FISH PASSAGE CENTER

MEMORANDUM

RE: Review Performance Standard Testing/ John Day 2010

RE: Review of Acoustic Telemetry Evaluation of Juvenile Salmonid Passage at John Day Dam, 2009 Draft Final Report

Figure 3.29. Spill treatments as prescribed (red line) and actual conditions (black line) in spring (repeated from Figure 3.22 for ease of reference)

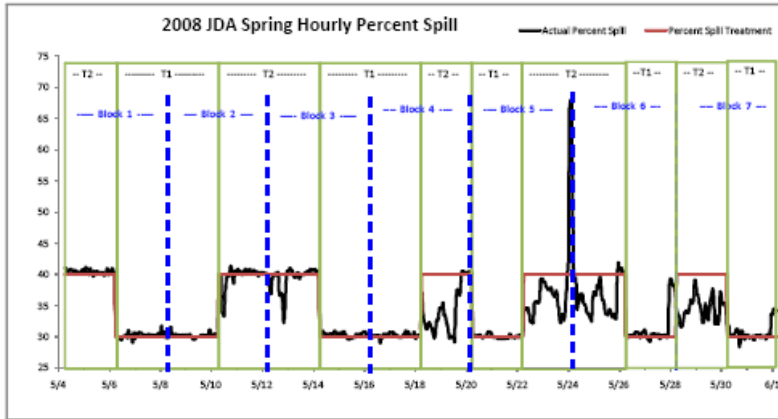
Results from analysis of PNNL 2008 paired release studies at John Day could not be replicated utilizing the data in the 2008 report

Based on our review of the PNNL 2008 acoustic telemetry study it is difficult to determine how the steelhead survival estimates were grouped to arrive at the numbers reported both in the PNNL 2008 report to the COE and in the Weiland et al. presentation to AFEP 2010. In both the 2008 report and the 2010 presentation by PNNL the paired steelhead survivals in 2008 were 99.1% for the 30% spill treatment and 97.2% for the 40% spill treatments. However, upon using the average survival for the virtual release blocks from the appendices of the 2008 report and the date blocks identified in Figure 3.29 from 2008 PNNL report, we estimated the paired release survival at were 99.0% for the 40% nominal spill treatment group when we took a simple average of the survival blocks, while the 30% group average survival was 97.7%. We also considered sample size weighted average estimates and found the same pattern; with the 40% spill test having a 99.2% average survival compared to 97.8% average for the 30% tests. Finally, we also pooled detection tallies for all blocks within each treatment and estimated a paired release survivals of 98.6% for the 40% treatment blocks compared to 97.6% for the 30% blocks. Our results are the opposite of what PNNL is reporting and lends confusion to the consideration and application of these results to operations decisions. In all of the methods we used to combine the data; the 40% blocks appeared to have higher survival than the 30% blocks, which is opposite of what was reported in the PNNL reports.
